RE: Long-Term 2 Enhanced Surface Water Treatment Rule, Proposed Rule, 68 Federal Register 47639, Docket No. OW-2002-0039

Formal Comments  
of the  
American Water Works Association

on the  
Long-Term 2 Enhanced Surface Water Treatment Proposed Rule  
68 Federal Register 47639, August 11, 2003

Figure 1. Temperature Profiles from Newport News, Va., and Tampa Bay, Fla.

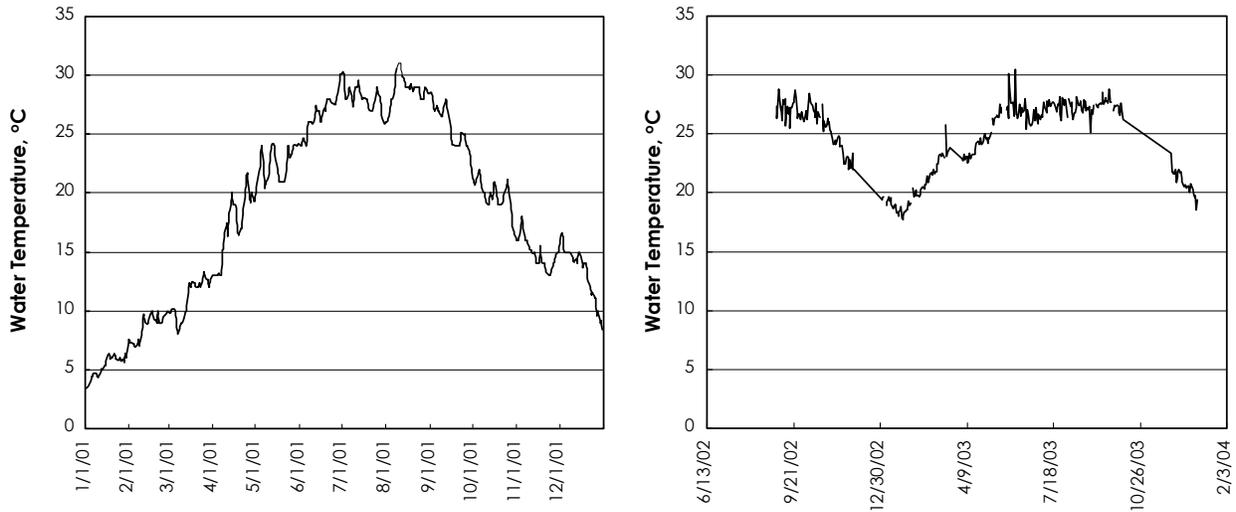
The current CT tables are limited to a maximum water temperature of 25 °C. Several systems treat waters with temperatures exceeding 25 °C during the summer months. Figure 1 shows frequency distribution profiles of water temperature for the Harwood's Mill Reservoir used by the Newport News (Va.) Water Works, and for the Colorado River water treated by the City of Phoenix, AZ. The data show that water temperatures can reach 30 °C or higher. AWWA recommends that the CT table be extended to a water temperature of 35 °C. The inactivation

model used to develop the CT tables was based on a dataset that included various data points at 30 °C and 37 °C. Therefore, the confidence in the calculated CT values at the high temperatures should be as good as those at the low temperatures included in the current CT tables.

Figure 2. Tracer Testing Results from an Over-Under Ozone Contactor in Florida

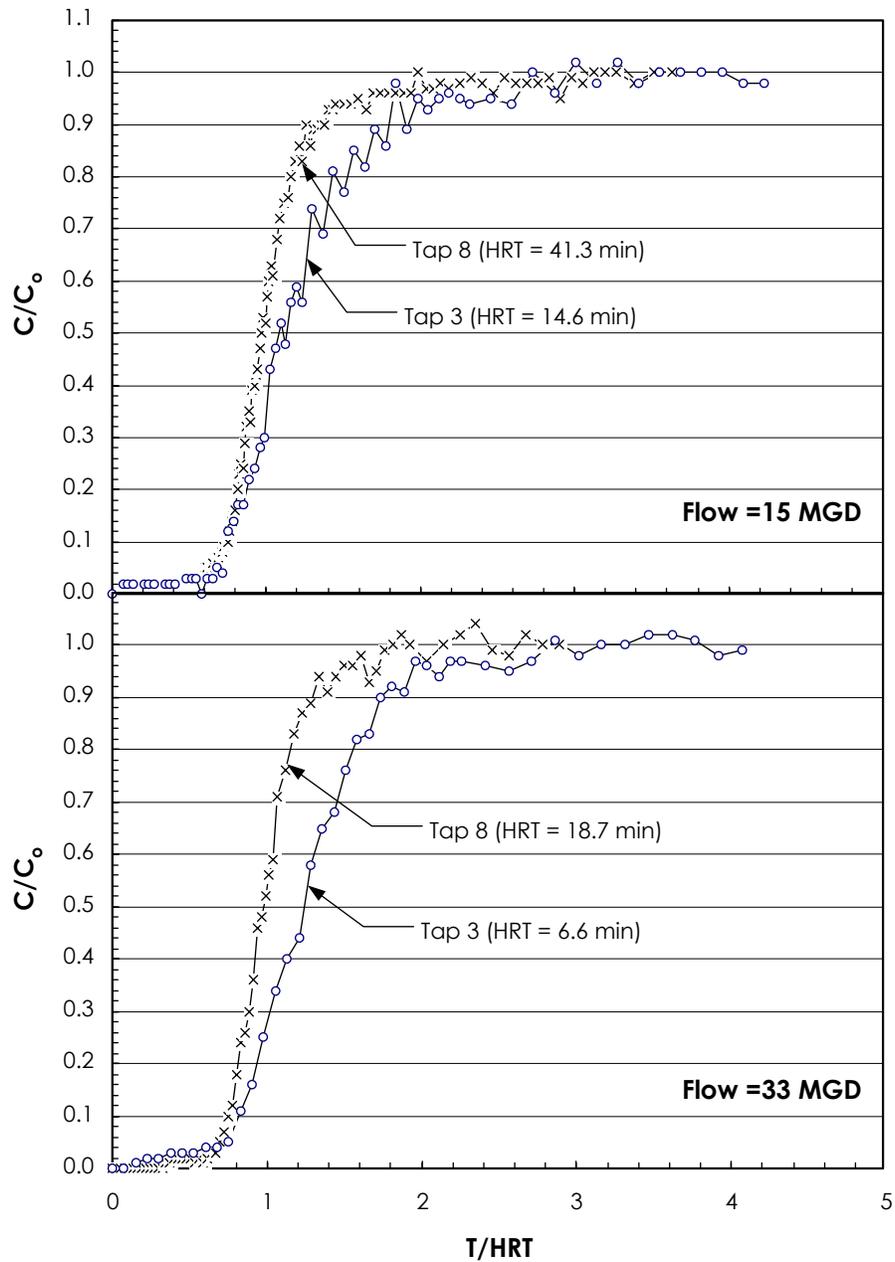
scientific data. Figure 2 shows tracer testing results from an over-under contactor in Florida. The tracer tests were conducted at two flows: 15 and 33 MGD, and samples were collected from Tap 3 and Tap 8 along the contactor. Although Tap 3 is about one third the distance to Tap 8, the  $T_{10}/\text{HRT}$  values at both taps are virtually identical. The rationale is that the flow pattern develops through the first few chambers of the contactor and does not necessarily change through the rest of the contactor. A plug flow contactor with a 10-minute contact time has the same flow pattern as a plug flow contactor with a 20-minute contact time. With  $T_{10}/\text{HRT}$  ratios in ozone contactors in excess of 0.6, ozone contactors experience similar behavior.

Figure 3. Factors Affecting Benefit Analysis

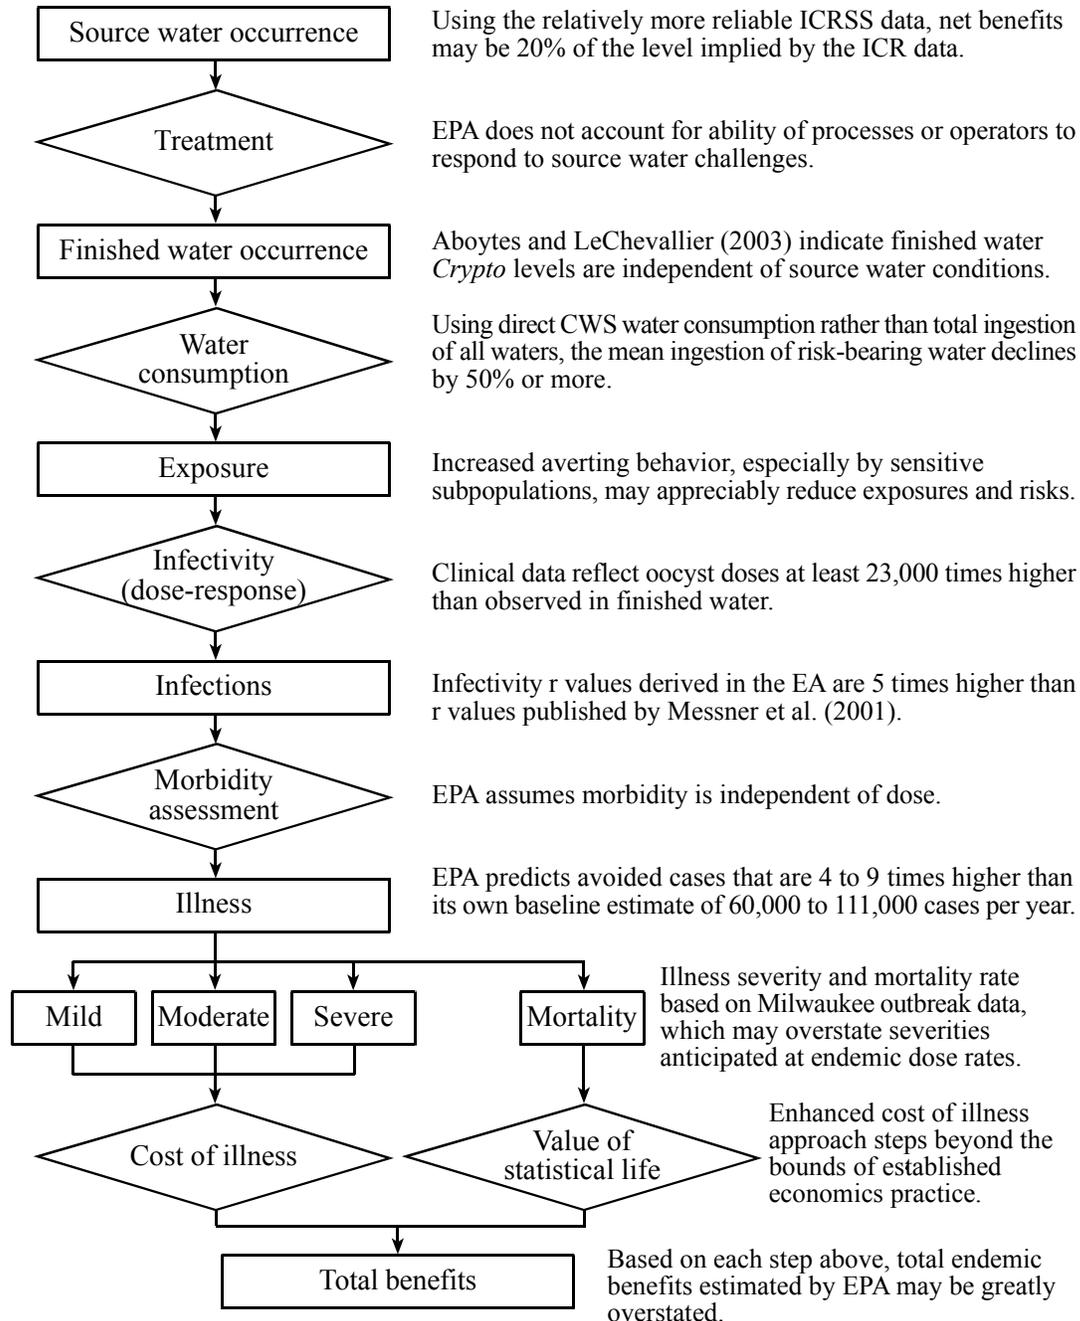
Figure 3 is a flowchart of the factors affecting each step of the benefit analysis. When examining the issues identified in Figure 3, the risk reduction benefits developed by EPA may be overstated in many ways. Compounding the changes at each step as depicted in the figure, the overall estimate of benefits derived by EPA could be an order of magnitude or more larger than a more plausible and likely estimate.
